Release of the Z8F6482 New Revision Series

October 7, 2021

Subject: Release of the Z8F6482 New Revision

Top Mark Diagram noting the location of the Date and BB Codes

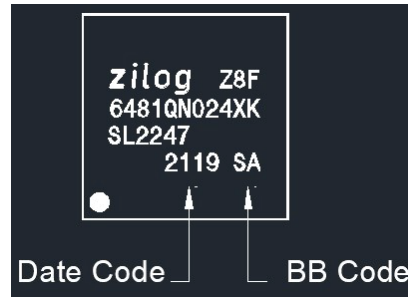
The change will take effect starting from date code 2123. However, during the transition period, there are also parts from date codes 2119 to 2122 that are affected by this change (New Revision). The New Revision can be identified on last line of top mark. Refer to the lot traceability codes table on next page to identify New Revision material.

Please refer to the following for the New Revision Date and BB Codes only table. All other Date and BB codes that **are not** identified in the table between date codes 2119 and 2122 are previous revision material.
